Scope of the Draft Regulation on Hydrogen and Fuel Cell Vehicles

Batch Tests and Production Tests of the Draft Regulation on Hydrogen and Fuel Cell Vehicles

Labelling of the Draft Regulation on Hydrogen and Fuel Cell Vehicles

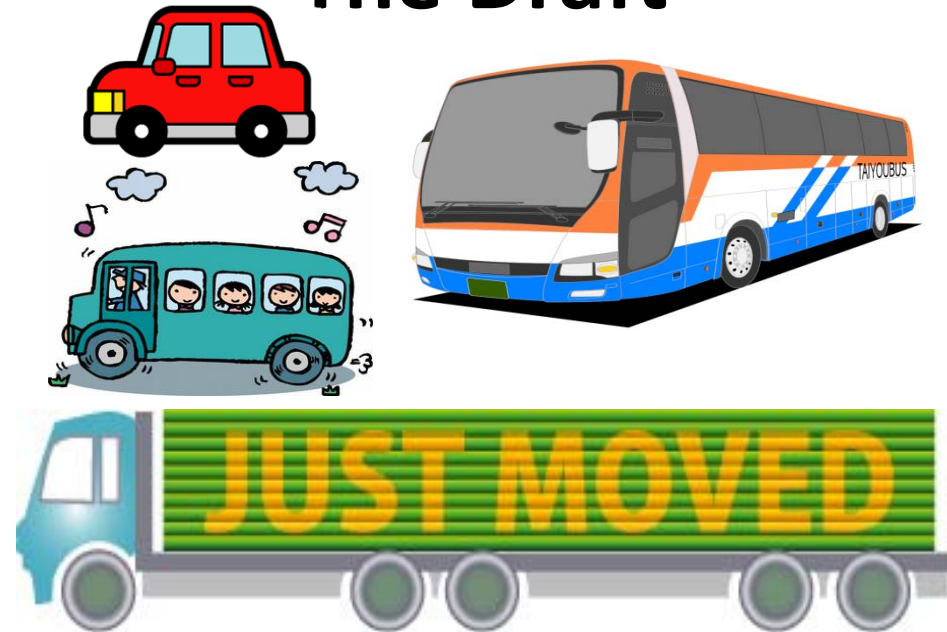
11,000 cycles ?

- Many Large vehicles drive long distances.
- Is 11,000 test cycles sufficient for large vehicles?
- Scope should not change from the GTR's scope.
